RENESAS TECHNICAL UPDATE

Product Category	MPU/MCU		Document No.	TN-RX*-A0244A/E	Rev.	1.00
Title	Errata to the Section on Electrical Characteristics in the RX66N Group User's Manual: Hardware		Information Category	Technical Notification		
Applicable Product	RX66N Group	Lot No.	Reference Document	RX66N Group User's Manual: Hardware Rev.1.00 (R01UH0825EJ0100)		
		All

This document describes corrections to the section on Electrical Characteristics in the RX66N Group User's Manual: Hardware, Rev.1.00.

Figure 61.41 MTU Clock Input Timing

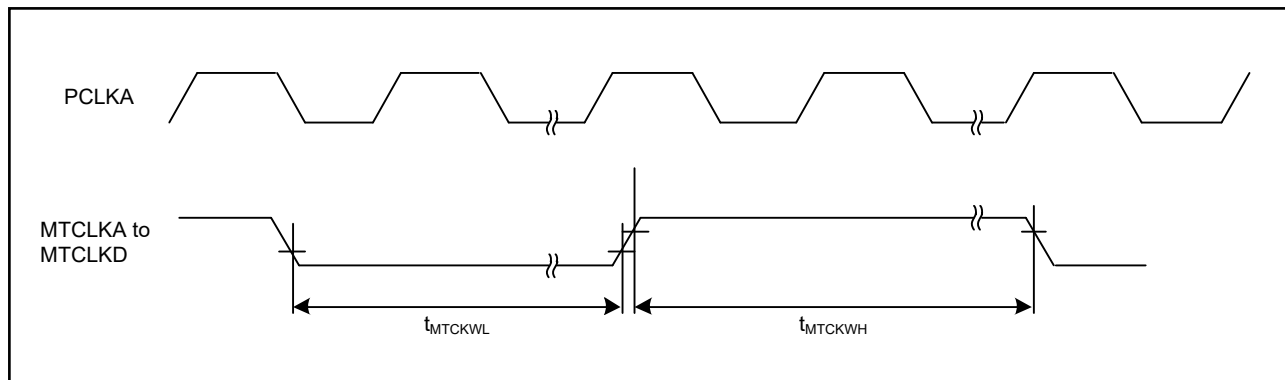
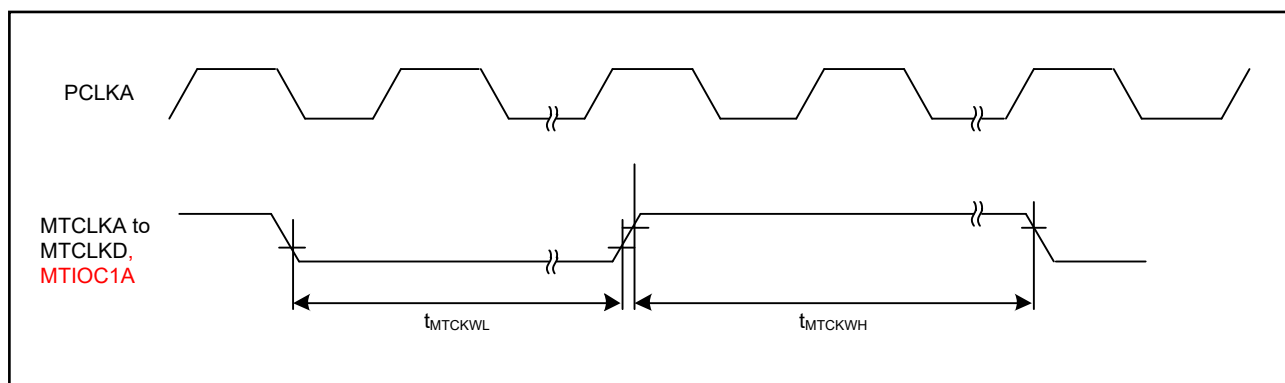
The MTIOC1A pin is added to Figure 61.41, MTU Clock Input Timing as follows.

Figure 61.51 Output Disable Time of POEG in Response to the Oscillation Stop Detection

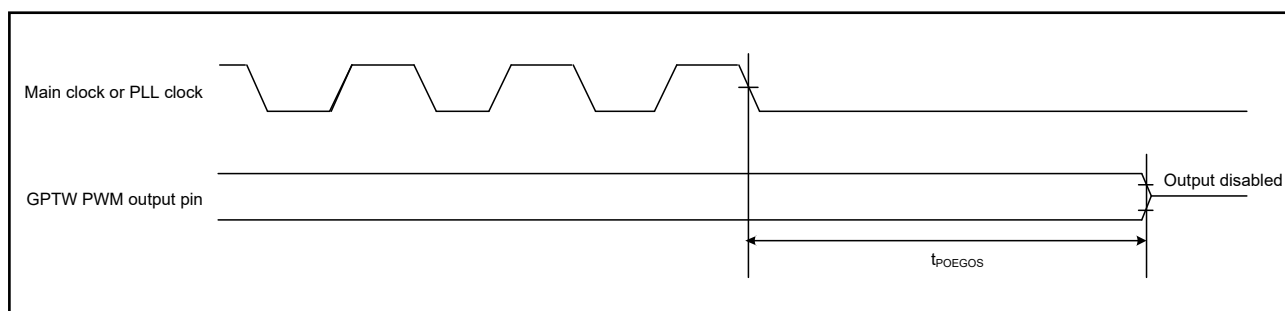
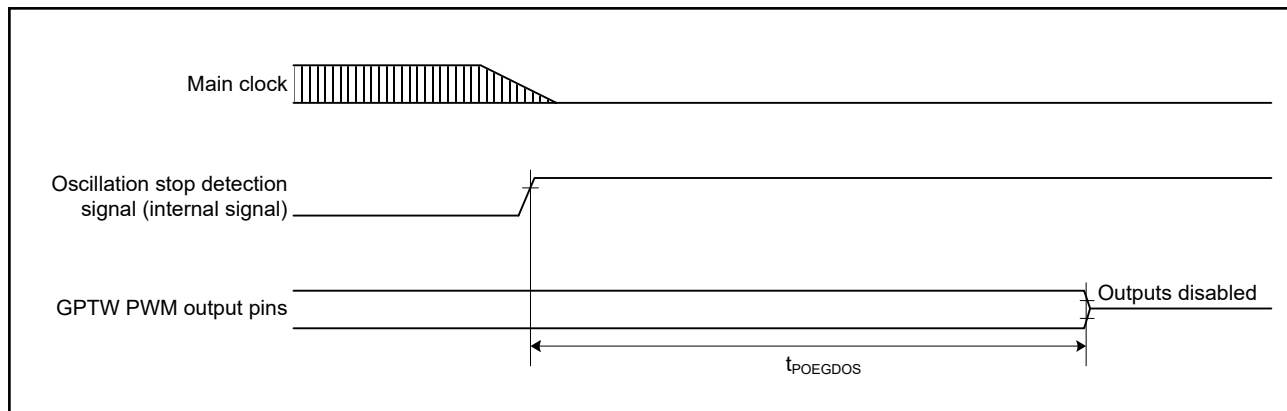
Figure 61.51, Output Disable Time of POEG in Response to the Oscillation Stop Detection is corrected as follows.

Figure 61.xx Simple IIC Bus Interface Input/Output Timing

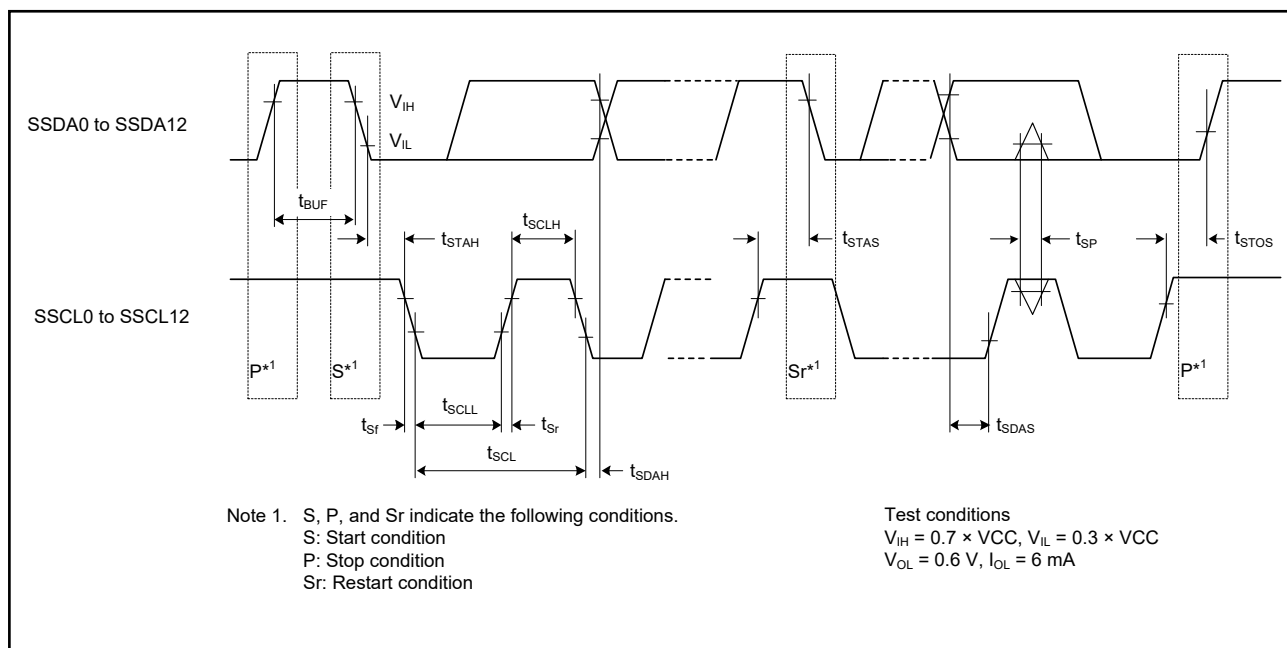
The following figure is added to illustrate the input and output timing of the simple IIC bus interface.
